NRC Advanced FEA Confirmatory Project

Al Csontos & Ted Sullivan
August 9, 2007

Advanced FEA Project: NRC Confirmatory Program

Advanced FEA Project: Phase I Results

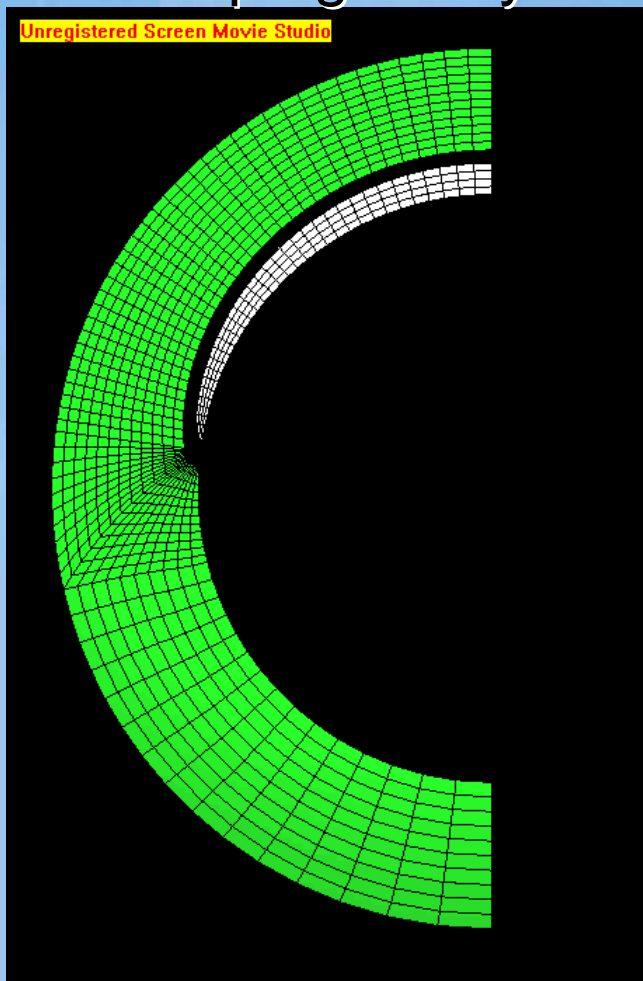
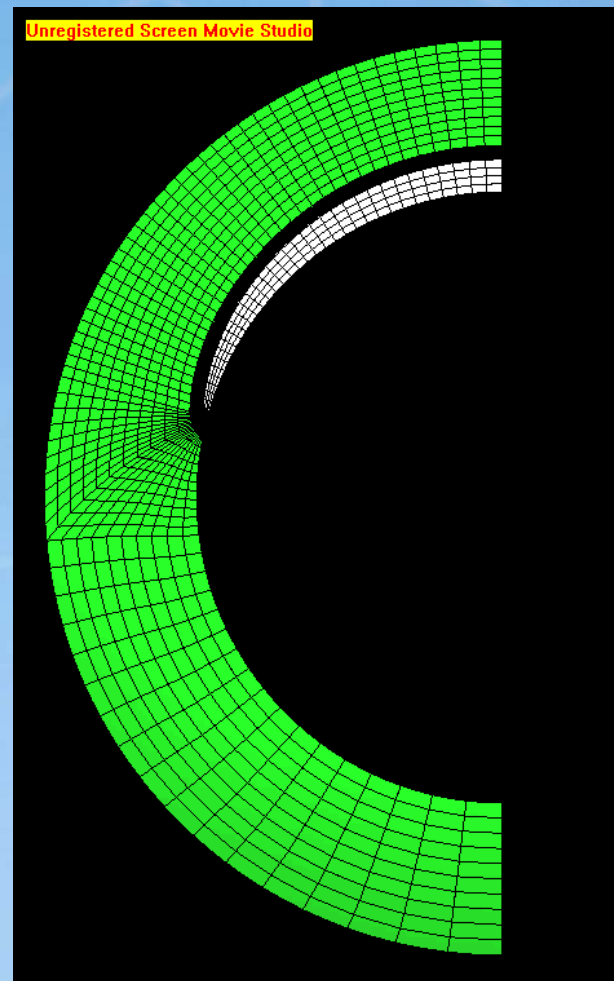
- Advanced FEA project evaluated in two parts
- Phase I Wolf Creek relief nozzle reevaluation:
 - Reevaluate scoping analysis results with new model
 - Good agreement between industry & NRC model results
 - Unlike the NRC Wolf Creek scoping study results, margins were predicted for the time between leak and rupture
- Phase II parametric sensitivity study:
 - Develop a matrix of sensitivity and bounding cases with plant specific nozzle geometries, loads, & WRS
 - Evaluate the margins between detectable leakage and rupture for the 51 DM butt welds in 8 plants susceptible to PWSCC

- Phase I Wolf Creek relief nozzle reevaluation:
 - 26% flaw depth
 - 21:1 c/a flaw ratio
 - ASME Section XI WRS
- Semi-elliptical assumption proved to be conservative for this ASME Section XI type flaw evaluation

Advanced FEA Project: Phase II Surge Line Results

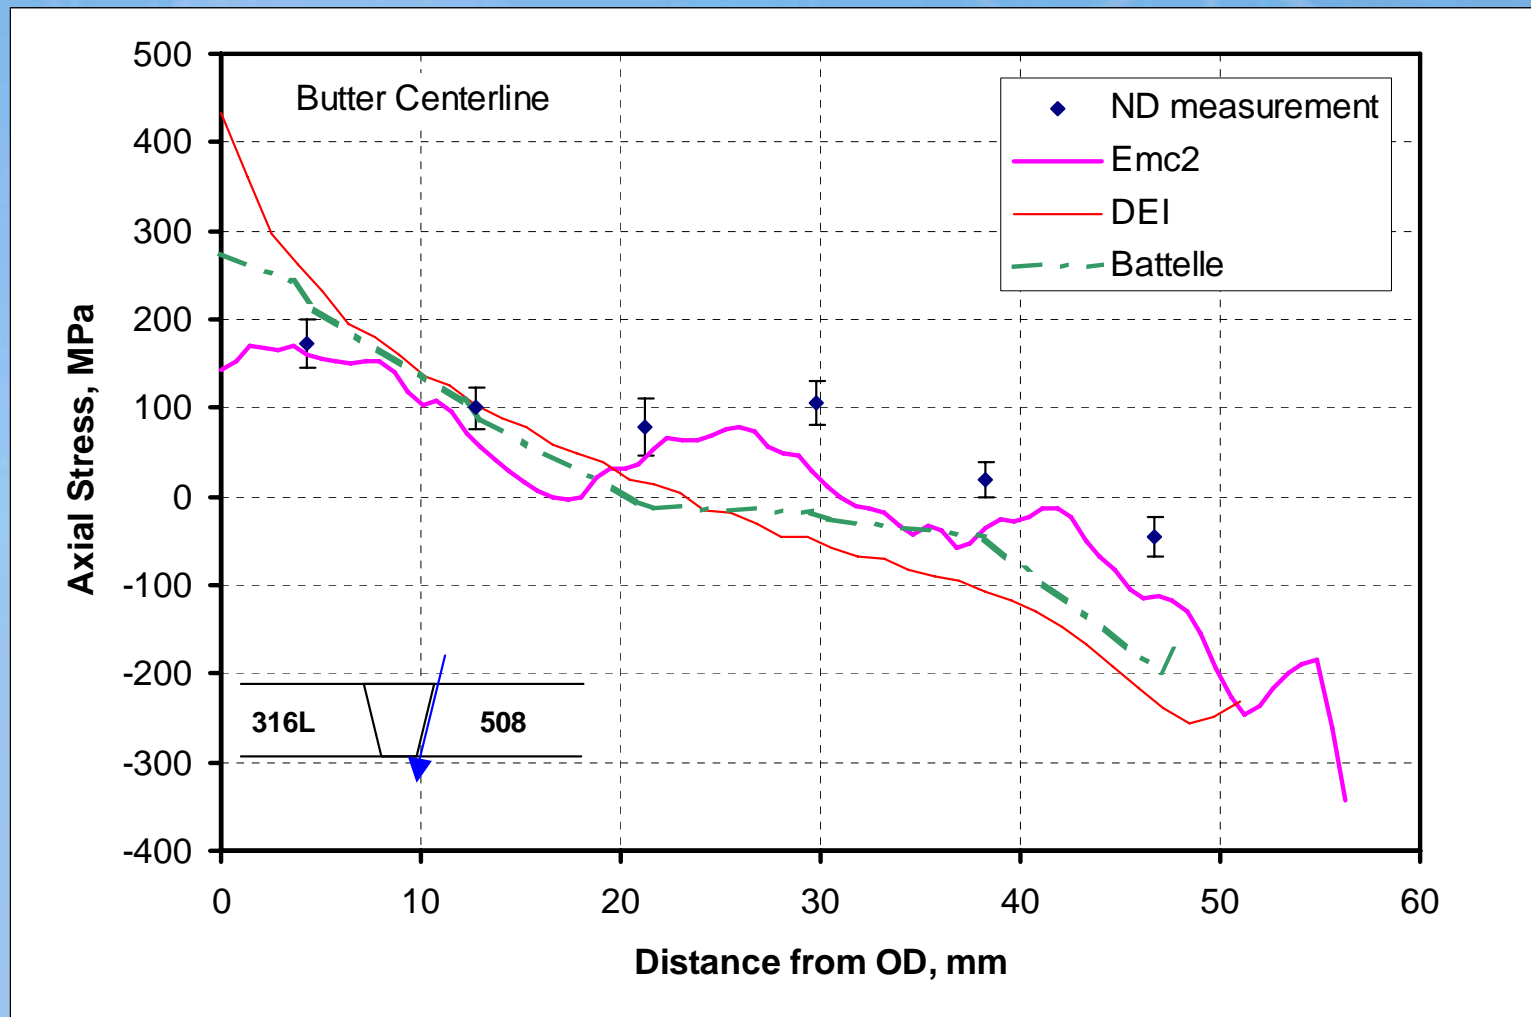
- Surge lines results confirm industry results cases 17-1/S1b, 17-2/17b, 20/20b, and 17-11/25b
- Some divergence occurred for cases 17-8/17a & 19-1/19b, but, substantial margins exist
